ADDENDUM NO. 1

SUMMARY OF QUANTITIES

UNIVERSITY CITY, MISSOURI
ACKERT WALKWAY IMPROVEMENTS
TAP-5402(617)

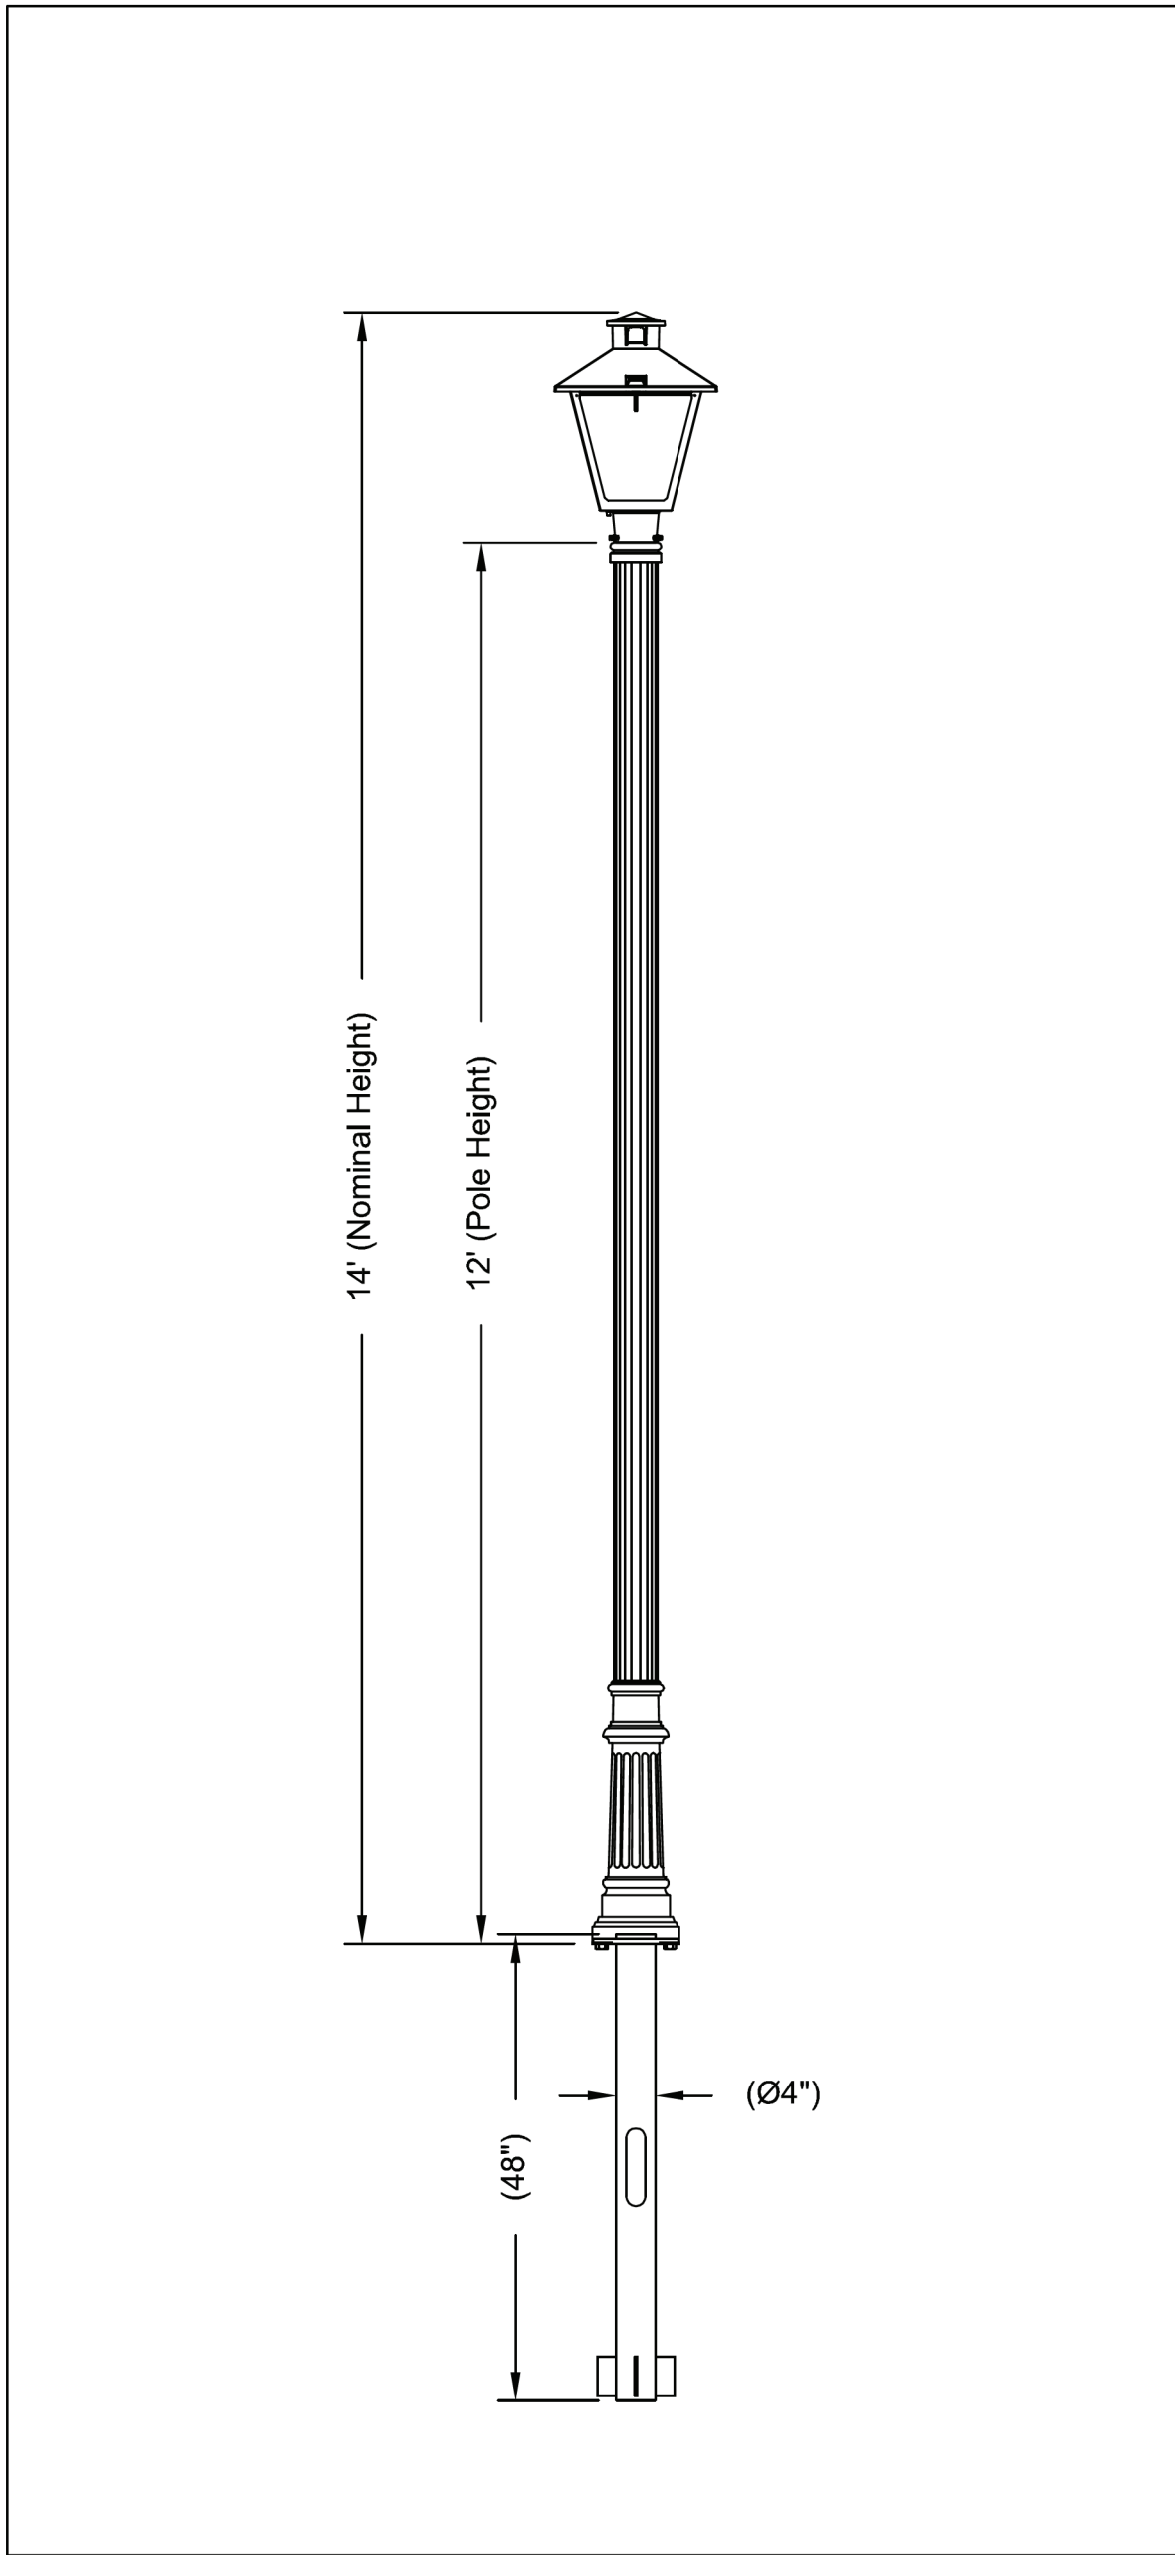
1" CABLE-CONDUIT IS LISTED AS THE PAY ITEMS FOR BOTH 2 COND. & 1 B.N. #6 AWG & #8 AWG. THE INTENTION WAS TO JUST USE THE WIRES AND NOT THE CONDUIT, SINCE THE WIRES WILL BE LOCATED IN A RIGID CONDUIT SYSTEM.

THE PAY ITEMS WILL REMAIN THE SAME AS CABLE-CONDUIT, BUT ONLY THE 3 WIRES FOR #6 AWG & #8 AWG WILL BE REQUIRED IN THE RIGID CONDUIT SYSTEM (NO CABLE-CONDUIT).

LIGHTING
SHEET 1 OF 4

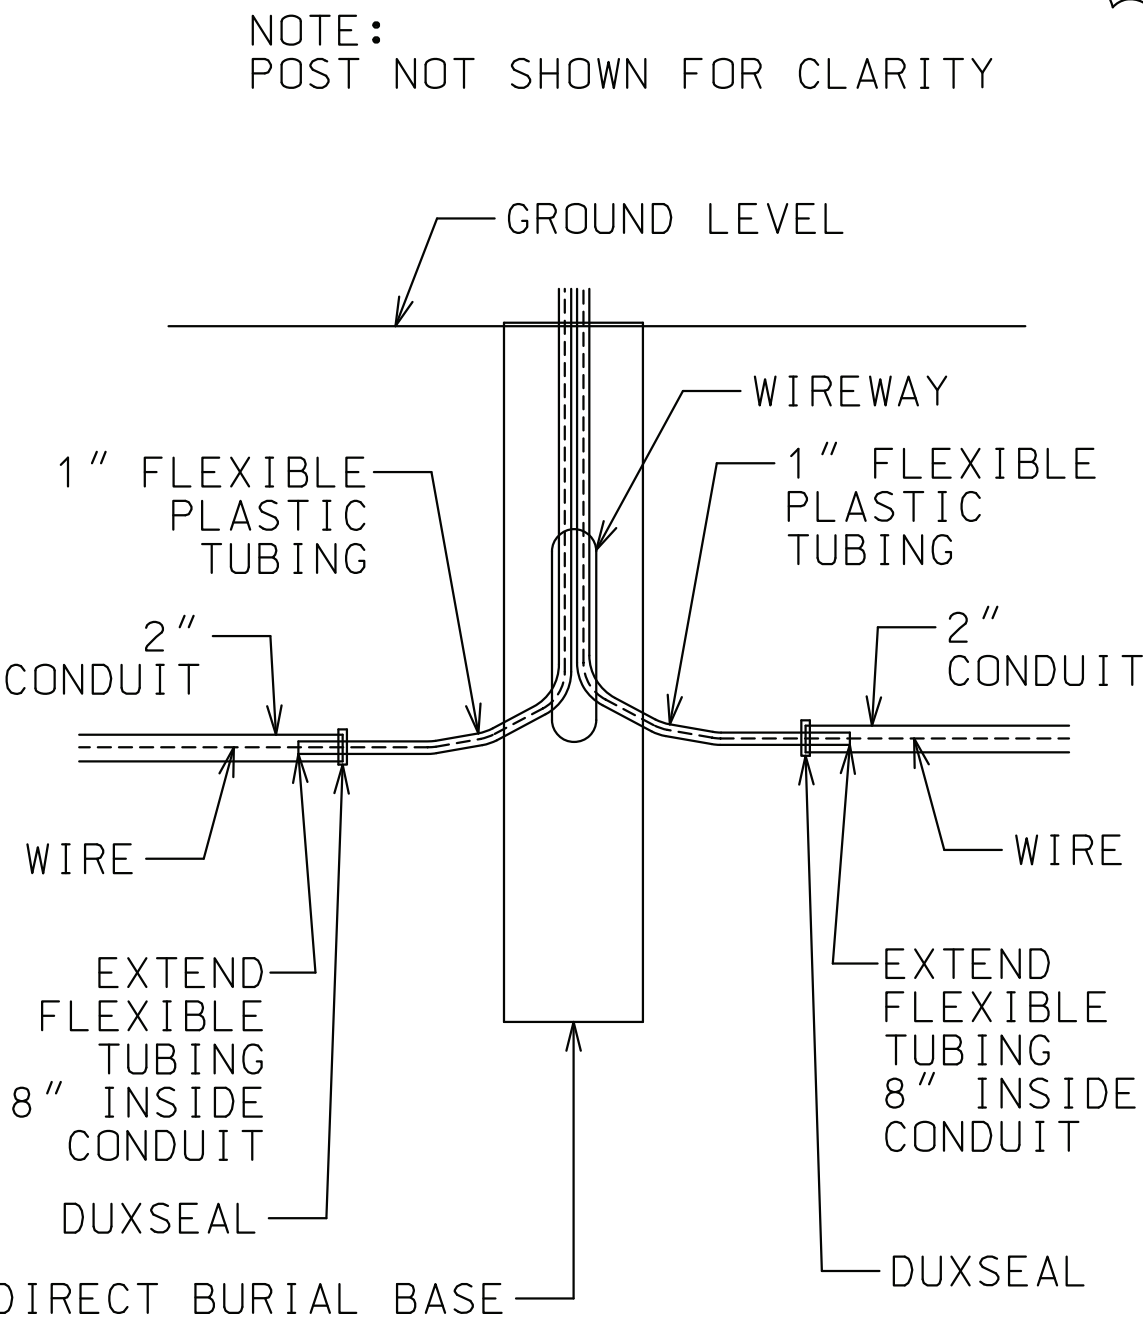
ADDENDUM #1
